# EMERGENCY AIRWORTHINESS DIRECTIVE

**AD #: 2004-06-51**

**2004-06-51 BOEING DEFENSE AND SPACE GROUP: Docket No. 2004-SW-09-AD.**

Applicability: Model 234 helicopters, with aft vertical shaft assembly, part number (P/N) 234D3300, serial number -181 or lower with a prefix of A, installed, certificated in any category.

Aft Vertical Shaft  
Assembly Inspection Area  
Figure 1

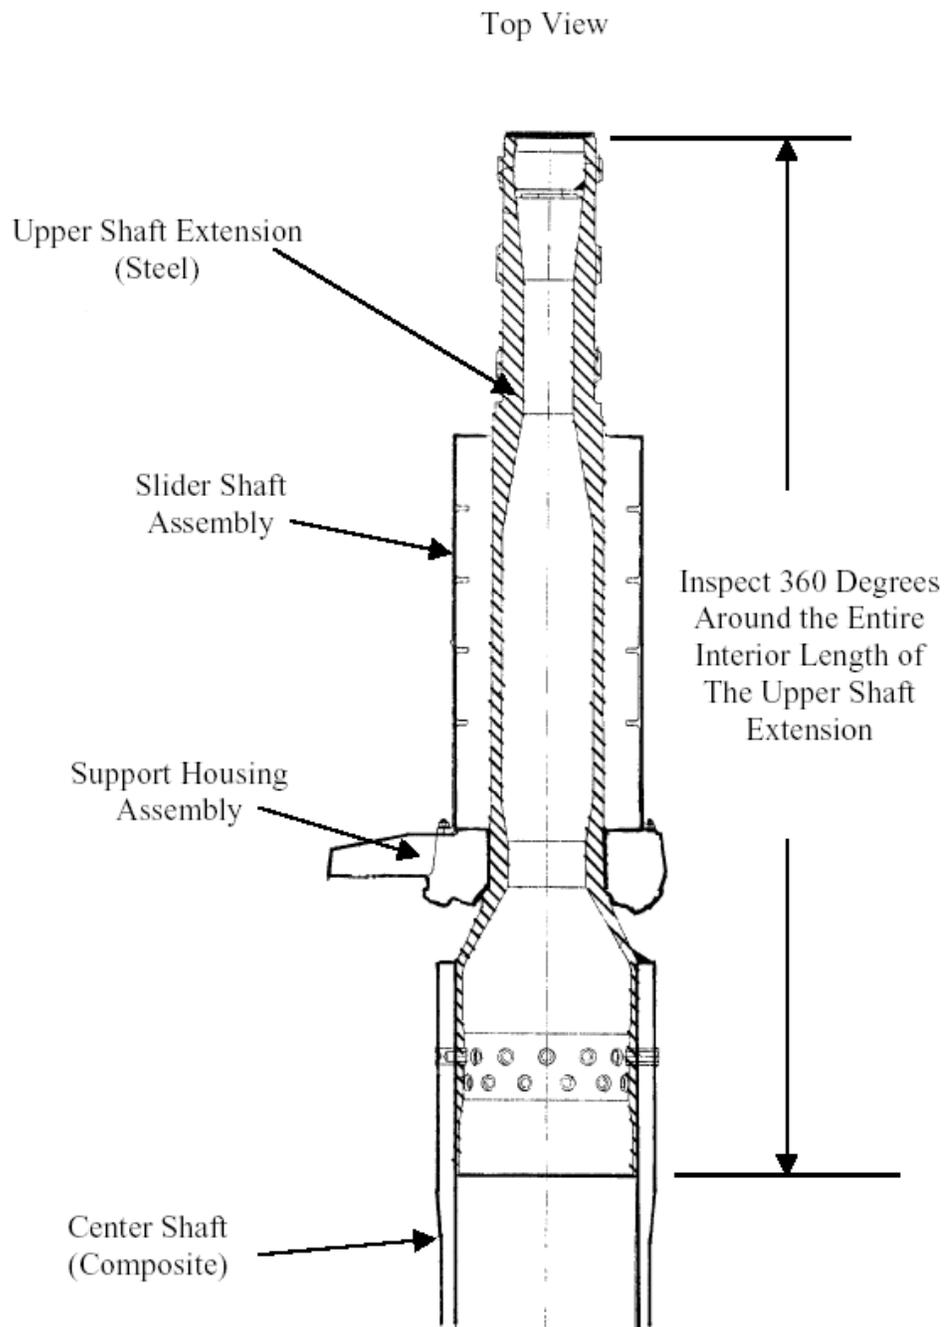
(5) Inspect the upper shaft extension, P/N 114D3248, using a borescope or other lighted device that provides direct visual observation of the interior of the aft rotor shaft. Inspect 360 degrees around the entire interior length of the upper shaft extension. If any crack is found, replace the aft vertical shaft assembly, P/N 234D3300, with an airworthy assembly before further flight. See the following Figure 1 of this AD for the area to inspect:

(3) Inspect the upper shaft extension, P/N 114D3248, using a borescope or other lighted device that provides direct visual observation of the interior of the aft rotor shaft. Inspect 360 degrees around the entire interior length of the upper shaft extension (see Figure 1 of this AD). If any crack is found, replace the aft vertical shaft assembly, P/N 234D3300, with an airworthy assembly before further flight.

Figure 2

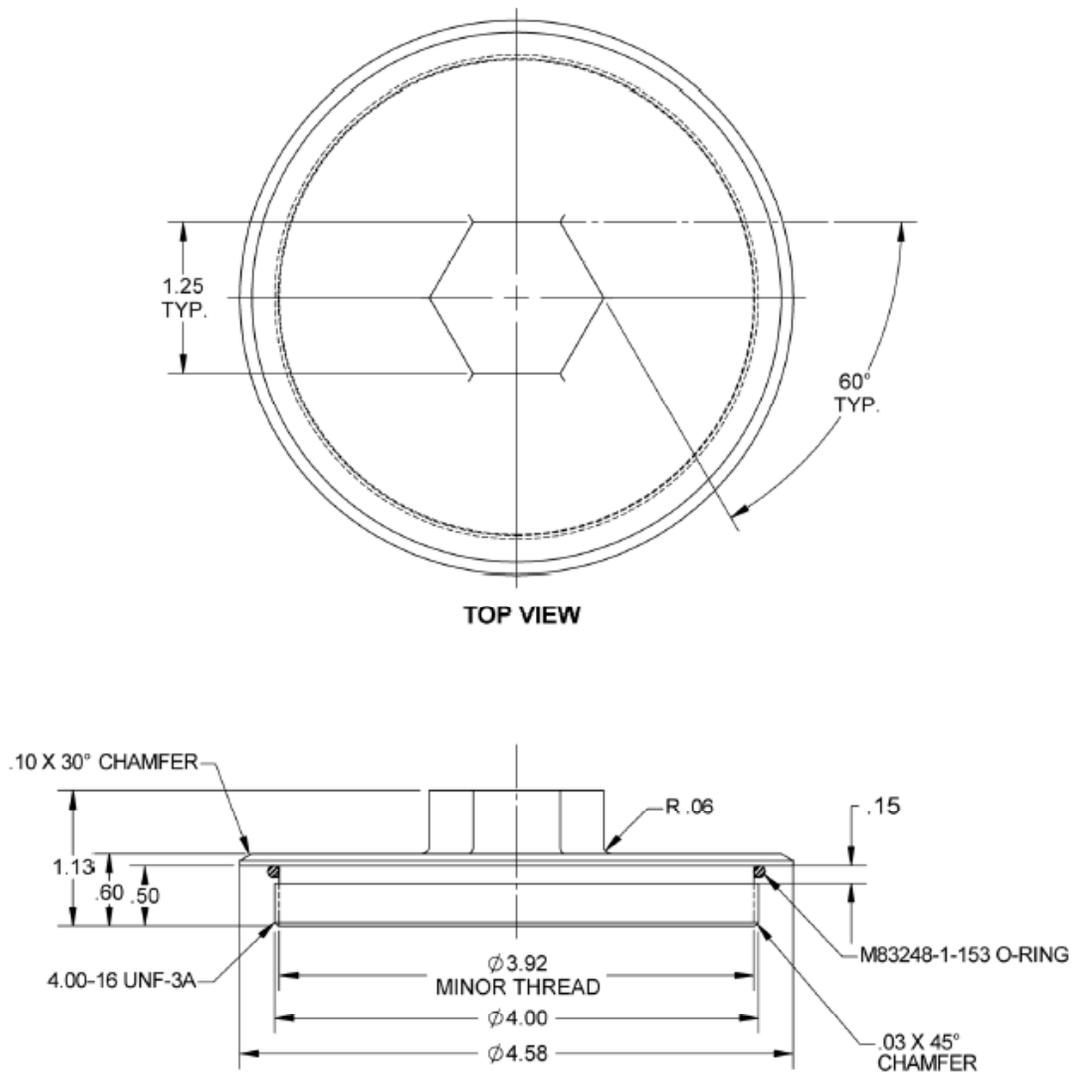
(7) Manufacture an aluminum-threaded plug to replace the rubber plug, P/N 114D1246-1. The replacement plug is to be installed in the internal threads on the top of the upper shaft extension. Machine the plug from a block of 7050-T7451, 7075-T6 or 6061-T6, with 4.000" -16 UNS-3A threads and a minor thread diameter of 3.920". Machine a hex head to the center of the cap to aid in removal. Machine the hex head to fit a 1/4" wrench.

See the following Figure 2 of this AD:

(8) Install the aluminum-threaded plug with an o-ring, P/N M83248-1-153, in the internal threads on the top of the upper shaft extension (hand tighten only). Assure the safety wire for the rotor hub nut is clear of the plug.
